Construction Documentation Report

Landfill Gas Collection and Control System Expansion 2011

Johnston County Landfill (Permit# 51-03)

I have completed a review of the revised Construction Document Report (Report). There are several “typos” or data missing in the As-built drawings which are described below:

SHEET: 10 OF 12
CAD FILE: ASBUILTS.DWG
PROJECT NO: 110065

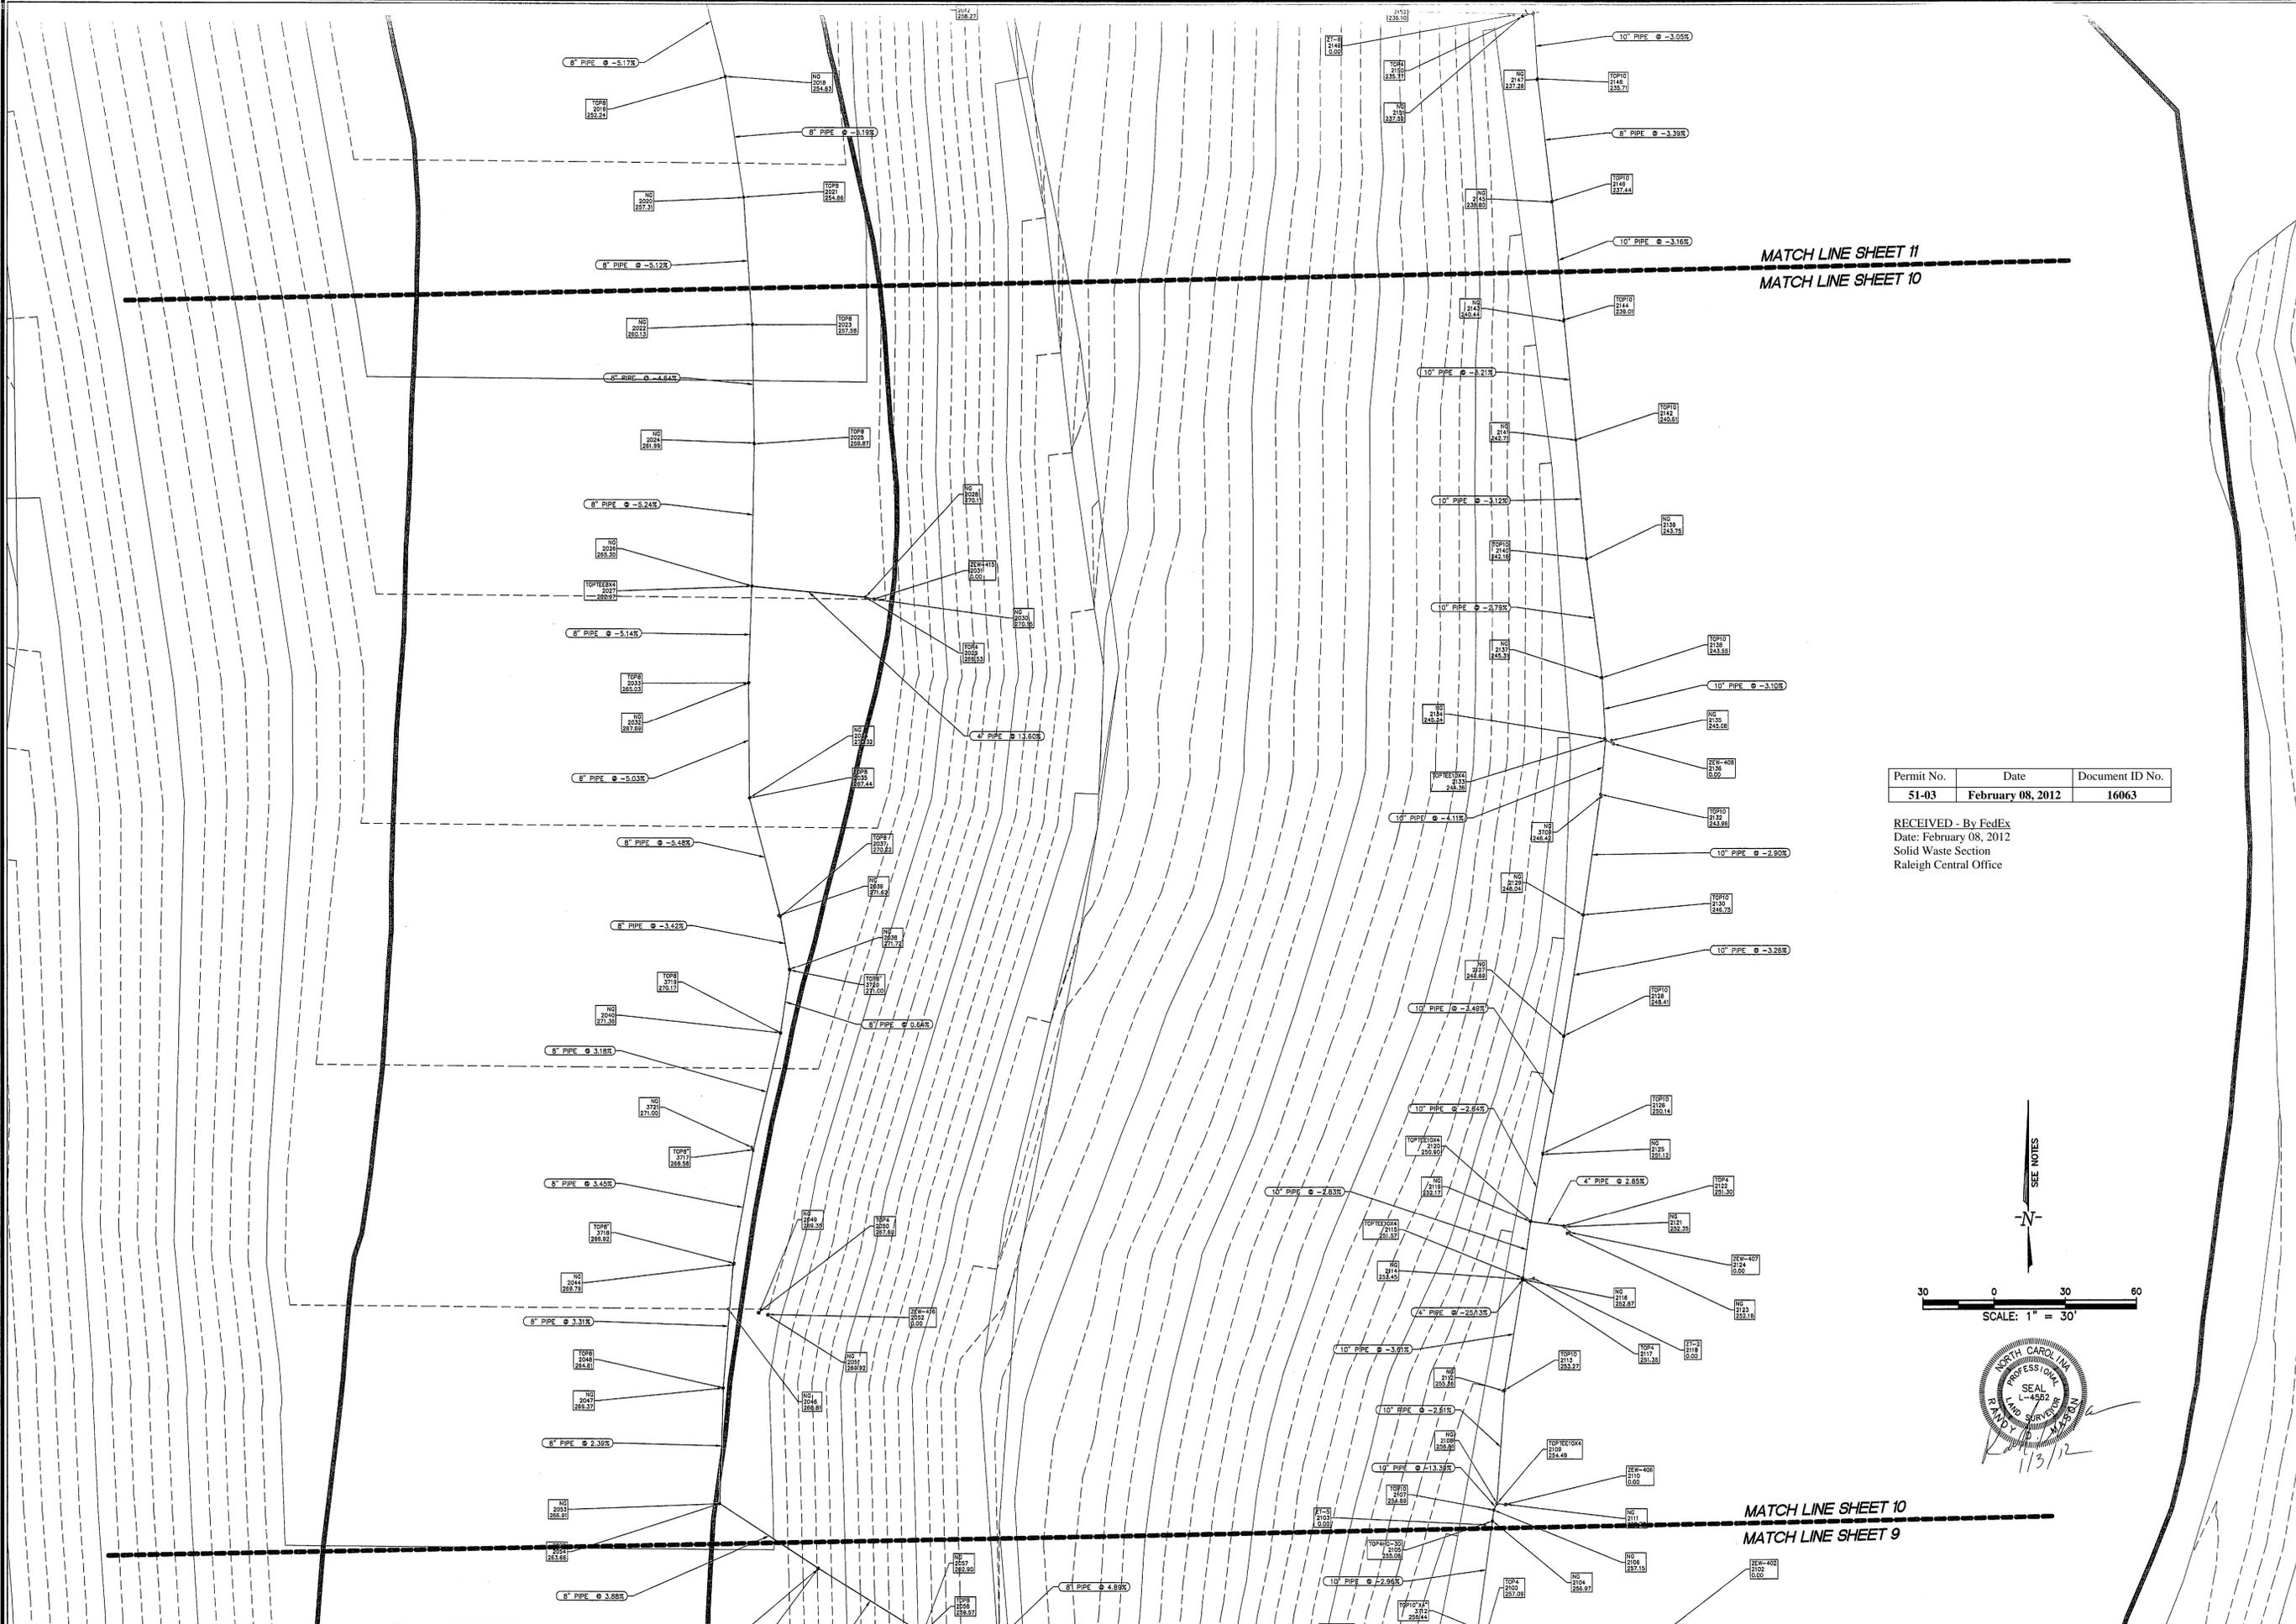
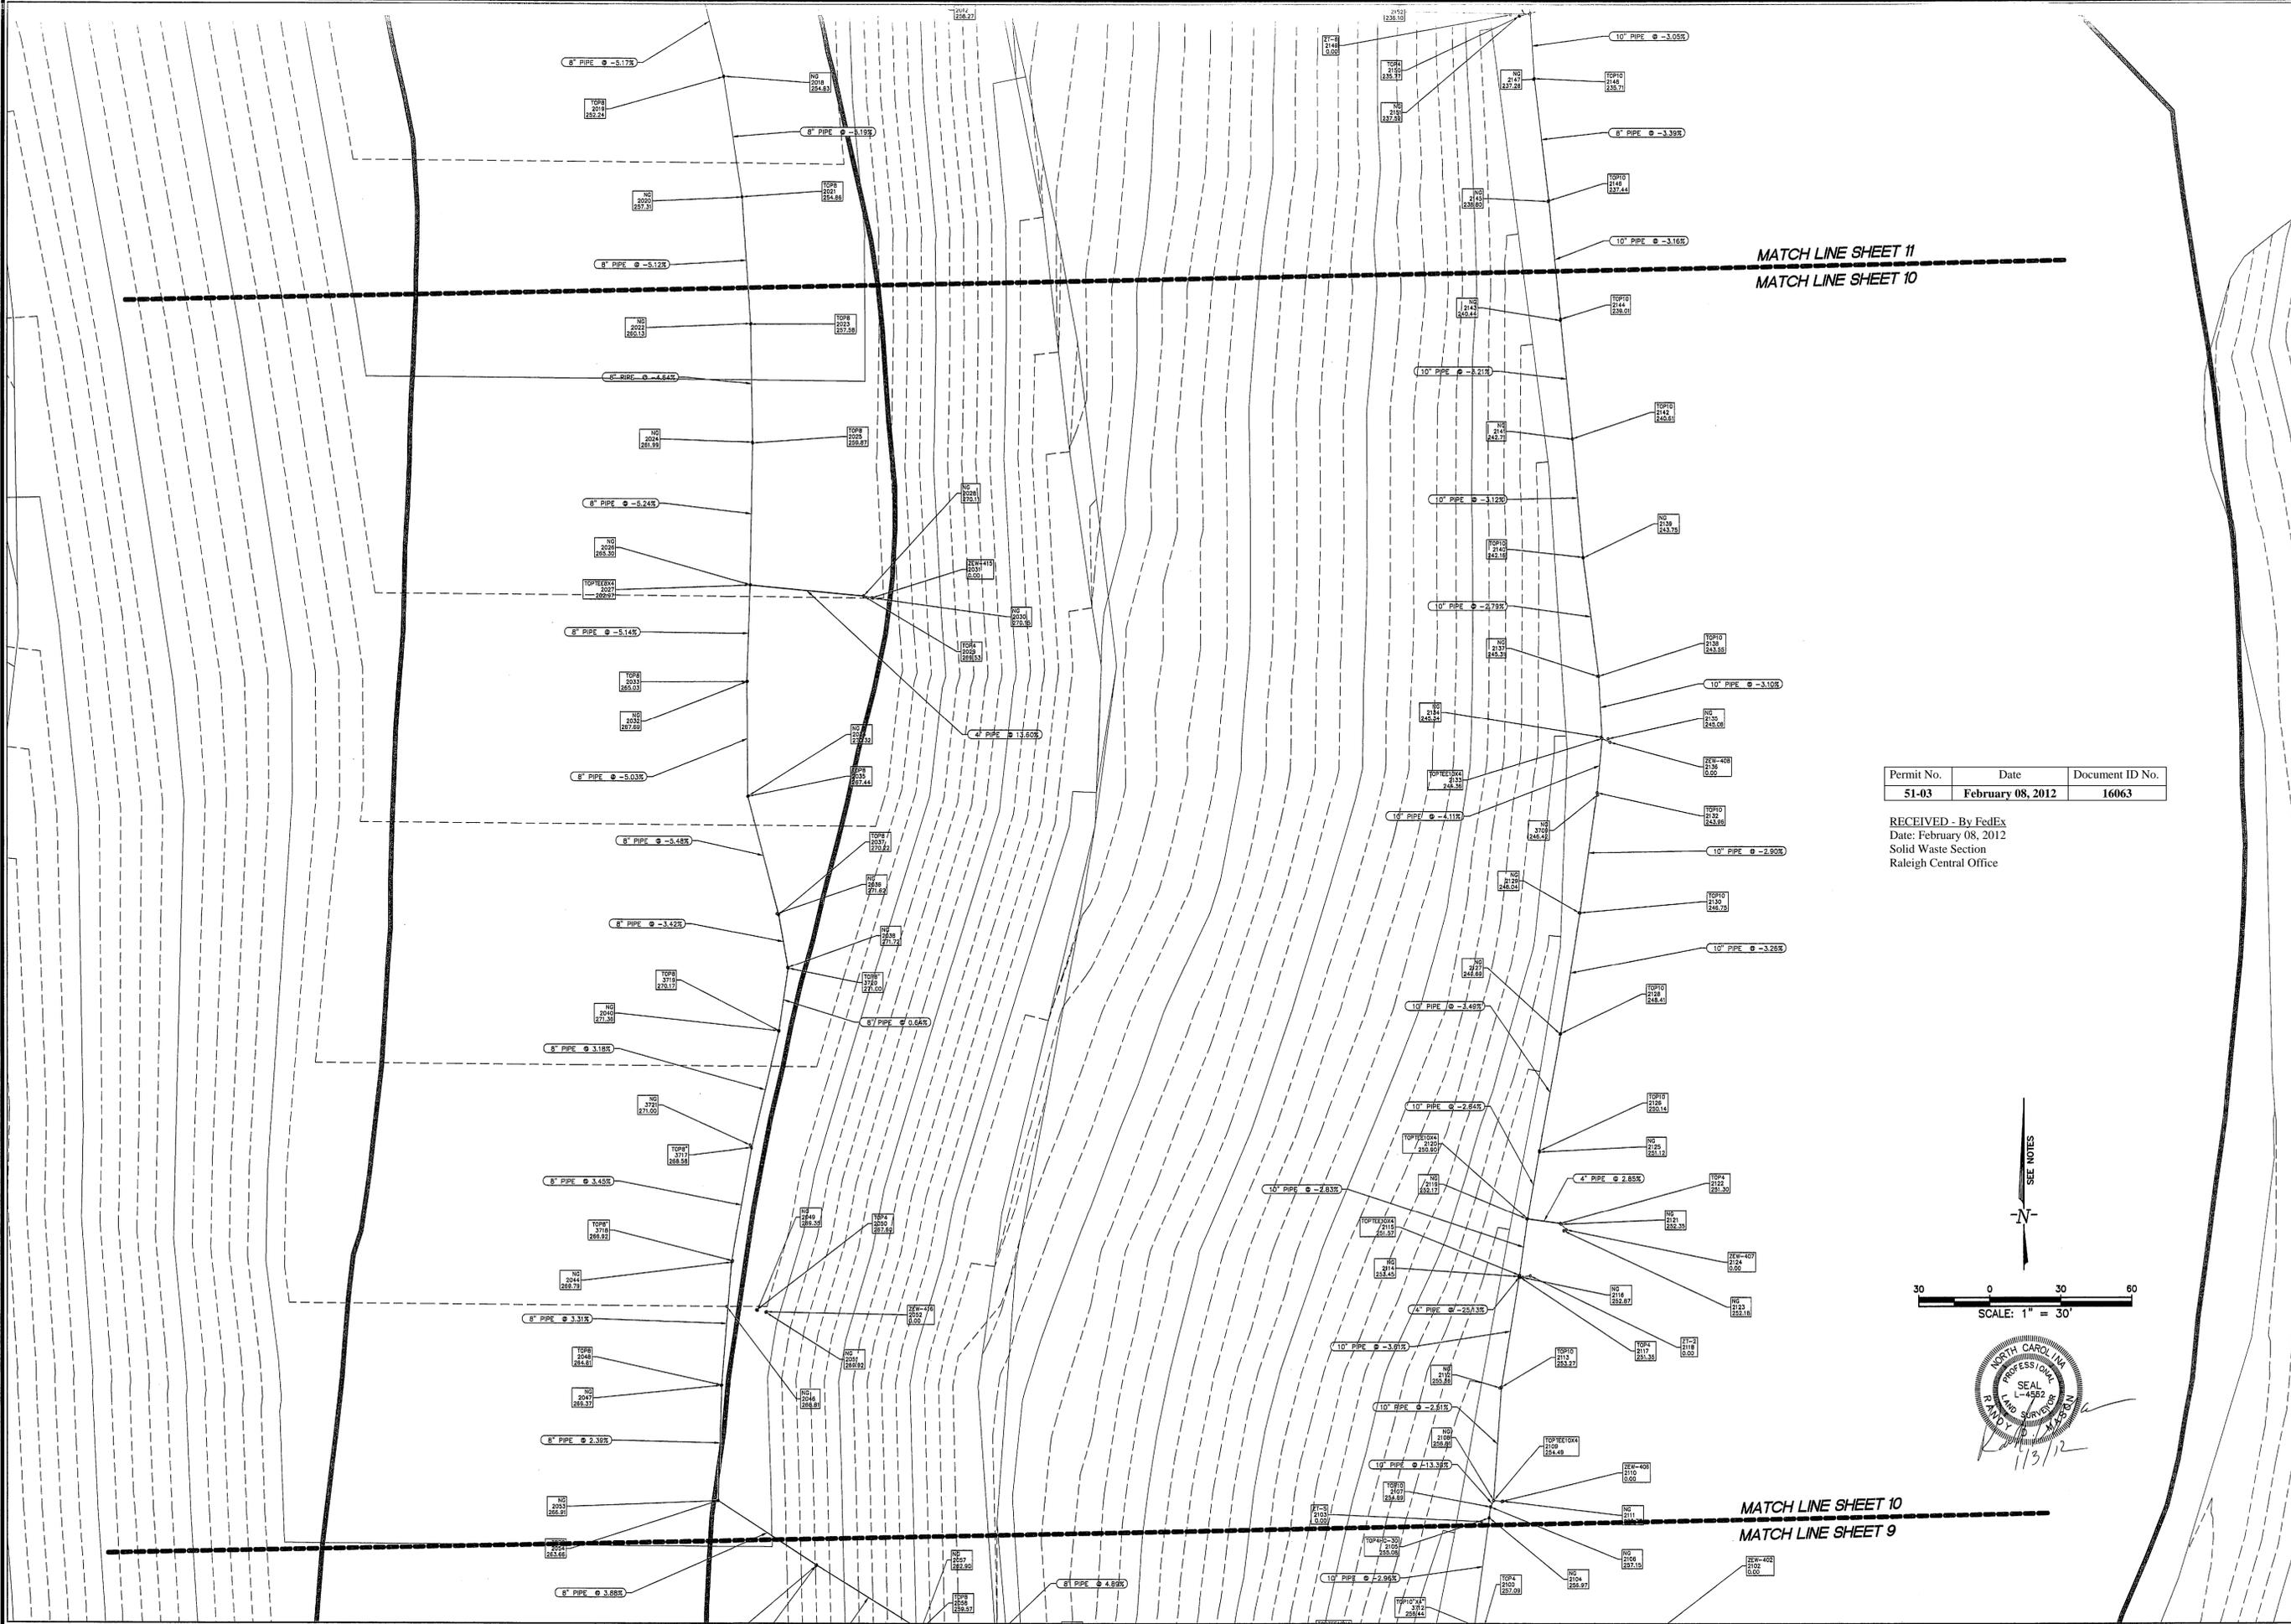
2. (Sheet 10 of 12) The well EW-417 was removed from the project scope according to the Report but showed on the drawing. Is it a typographic error? Or will this be the well EW-416 which is missing from the drawing? Please clarify.

SHEET: **11** OF **12**

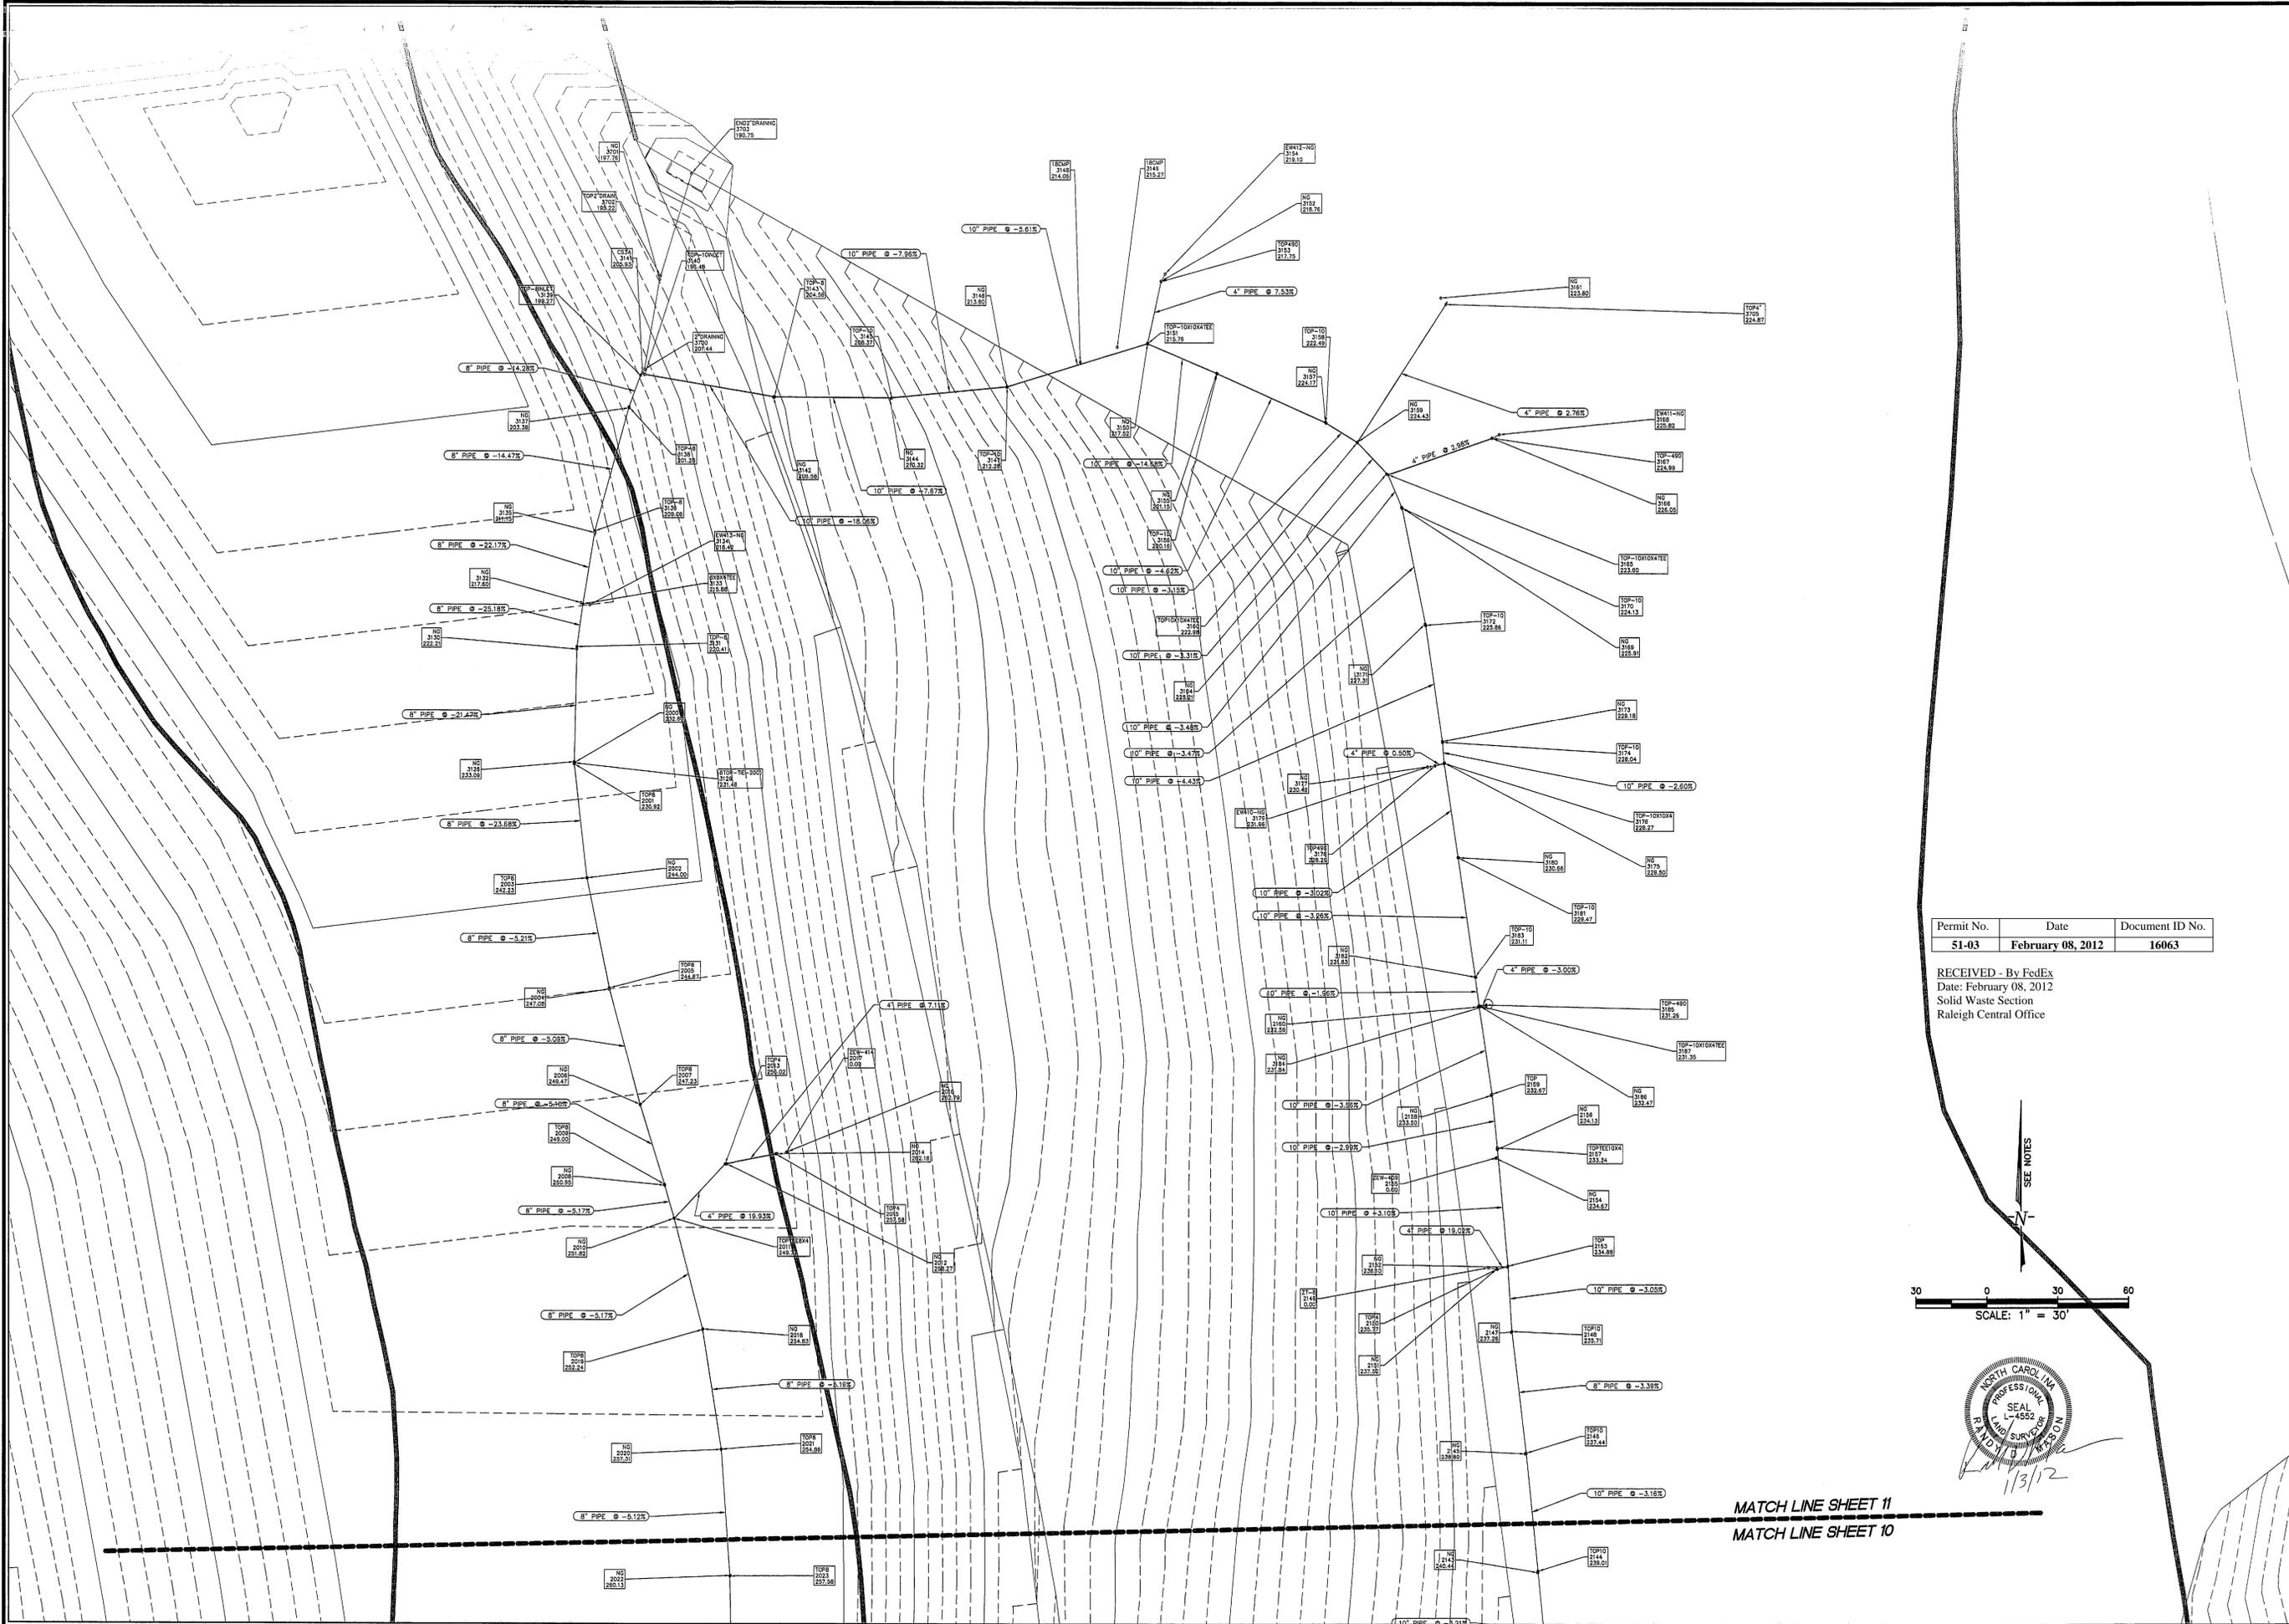
3. (Sheet 11 of 12) The well EW-409 and EW-414 are missing from the drawing. There is “ZEW-413 (Point #2017) located in the proximity of EW-414; is this well EW-414? Please clarify.
